## Comments to Reviewer 2:

This is a useful study of the impacts of human development on two ephemeral streams in Spain. I believe this is an interesting case study, which documents many useful observations. However, there are a number of revisions that I believe are necessary before the paper is ready for final publication. A few general comments are provided immediately below, with line-specific suggestions following.

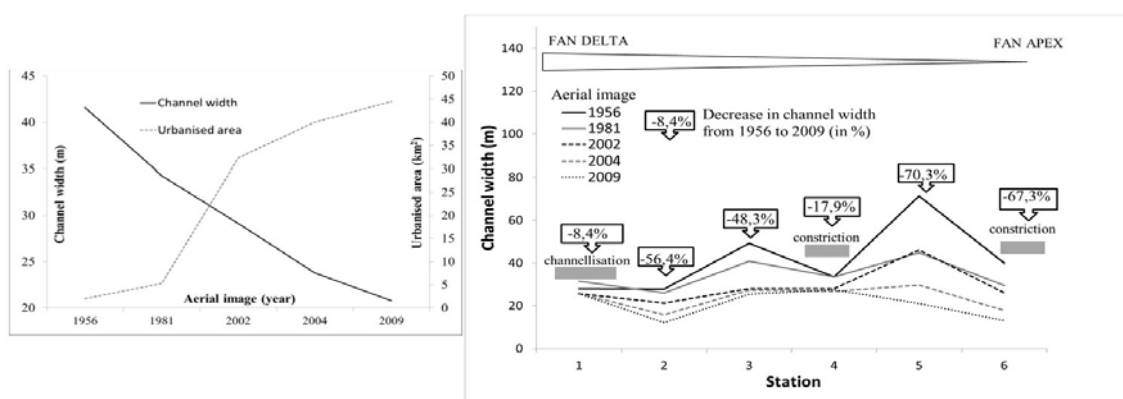
Second, the study has generated a considerable amount of quantitative information, but the text is largely qualitative and descriptive in nature. I would urge the authors to make better use of their quantitative predictions. Also, I believe the paper would benefit from a more rigorous description of the study catchments and compare/contrast of the two.

*We have introduced further explanations on text and figures in order to better support our results.*

*We also did a new figure:*

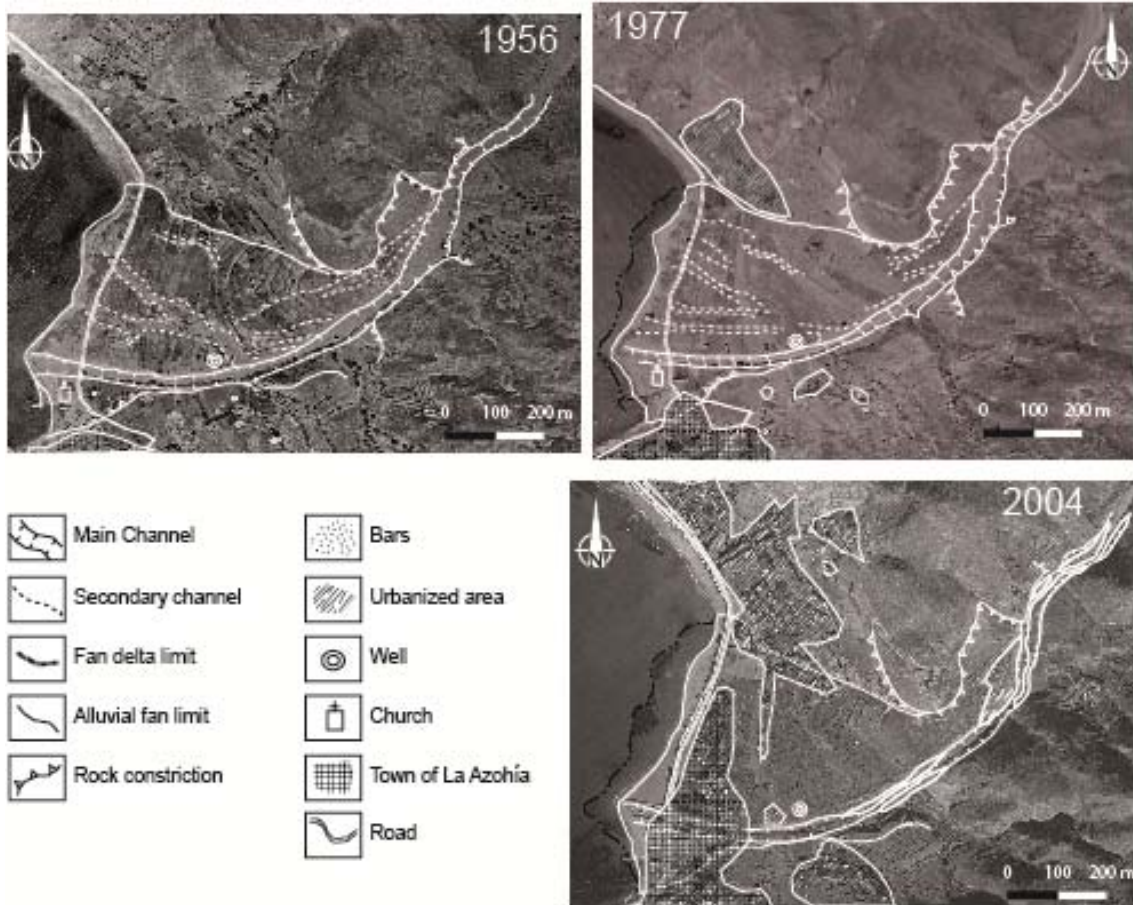
Figure 5: Possible to thicken the lines slightly or increase contrast between black lines and the background photo to allow the mapped features to be more easily studied? This figure is important and more could be done to allow the reader to connect the features discussed in the text with where they can be observed in the photos (perhaps using some unobtrusive labels?).

*This has been done:*
